LS1012A Reference Design Board Errata

This document lists and describes all known errata for the LS1012ARDB. It also describes the available workaround for each erratum and detailed erratum explanation, where needed.

Figure 1. E-00001 workaround

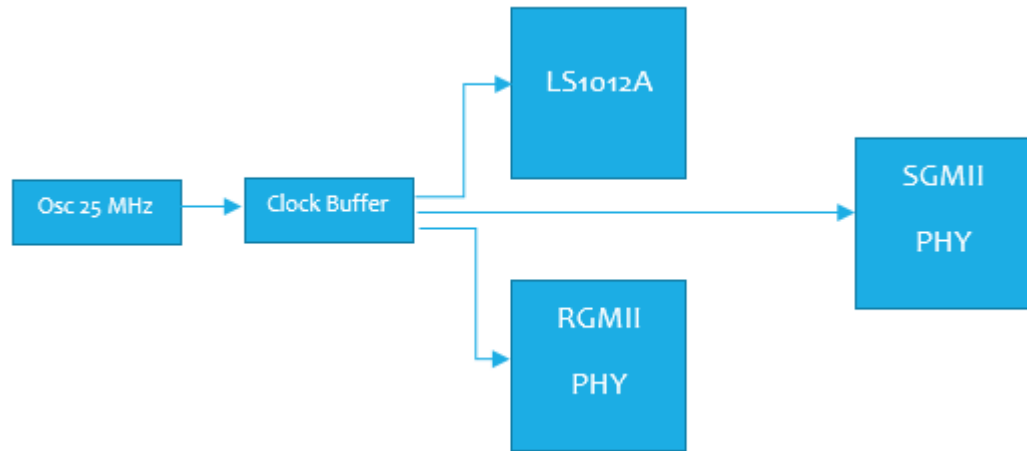
E-00001: LS1012A and Ethernet PHY clock inputs from same 25 MHz clock source

Description: Due to the SGMII PCS bug identified in the LS1012A SoC, the Ethernet PHY 25 MHz input and LS1012A 25 MHz clock input need to be sourced from same source.

Impact: SGMII CRC errors observed on link and the link is not stable.

Workaround: It is not possible to make any workaround on the Rev C boards. Refer to Rev D schematics for implementation of updated clock architecture.

Fix plan: The permanent fix will be available on the Rev D and higher boards.

Figure 2. E-00002 workaround

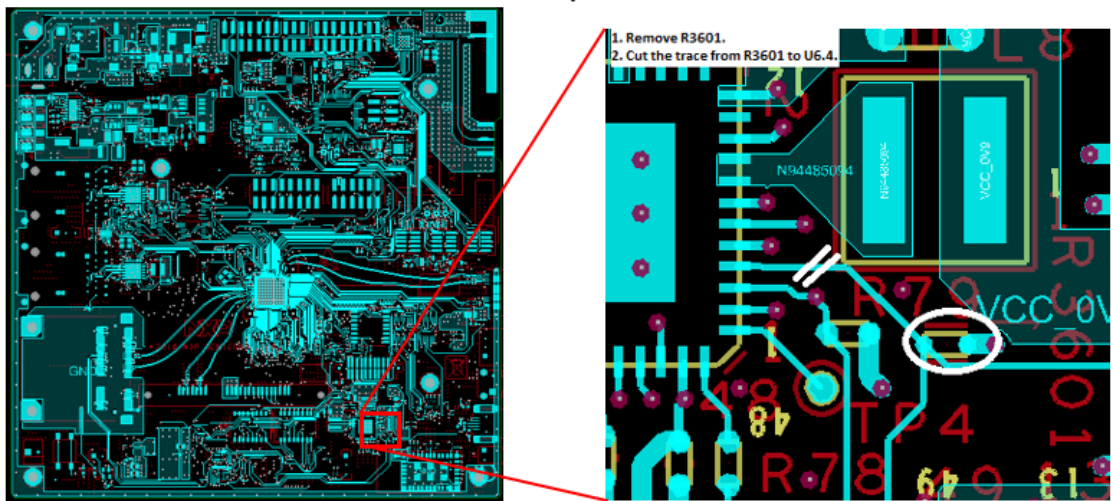
E-00002: USB 3.0 HDD drive is showing intermittent failures during enumeration and data transfer

Description: USB 3.0 HDD fail during data transfer and enumeration. The USB power switch asserts power fault. The root cause is traced to battery charger and power mux circuitry. This circuitry loads the VBUS and the power switch disables VBUS along with the POWERFAULT assertion.

Workaround:

1. Remove the Li-Ion battery, if it is connected on connector J2.
2. Unmount R3601.
3. Cut the trace from R3601 to the U6.4 pin.

Fix plan: The permanent fix will be available on the Rev D and higher boards.
